Product Change Notification (PCN)

Change Notification: **PCN-US-20131101-IDC rev06**

Products Affected: **AWLP-14/3.2-T**

Document: Drawing

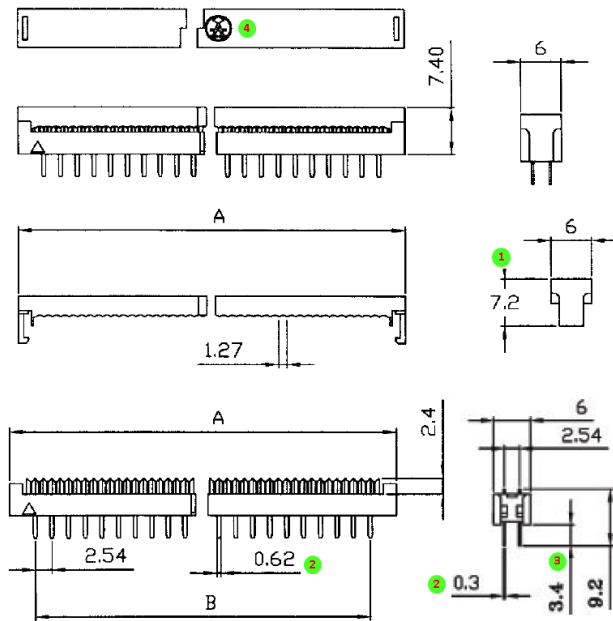
Previous part number	New part number	Drawing number
AWLP-14/3.2-T-R	AWLP-14/3.2-T	ASS_1197_COrev06

AWLP-14/3.2-T-R
Old version

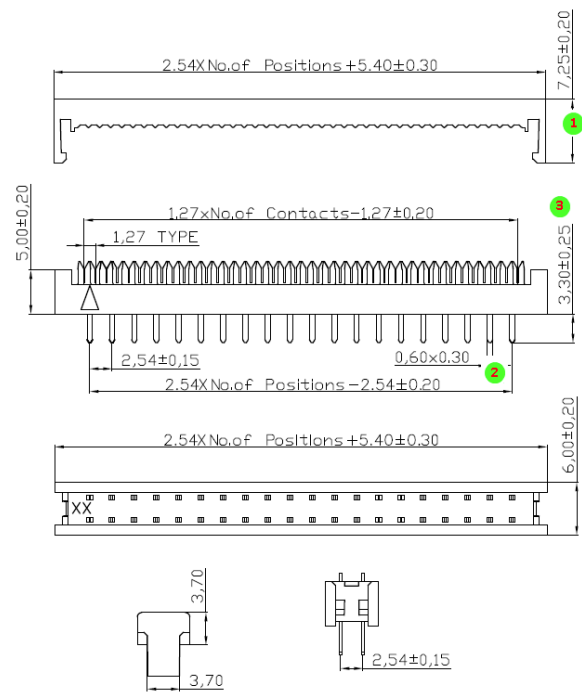
1. Amendment of the specification
2. Withstand Voltage: New: 1000V AC/DC
3. Current Rating: New: 3.0Amp
4. Operating Temperature: New: -40°C to +105°C
5. Change of dimensions, see sheet 3
6. Listed drawing # replaces all prior drawings, see sheet 2

- 1) 7.2
- 2) 0.62*0.3
- 3) 3.4
- 4) "A" logo

AWLP-14/3.2-T
New version

- 1) 7.25
- 2) 0.60*0.30
- 3) 3.30
- 4) without "A" logo
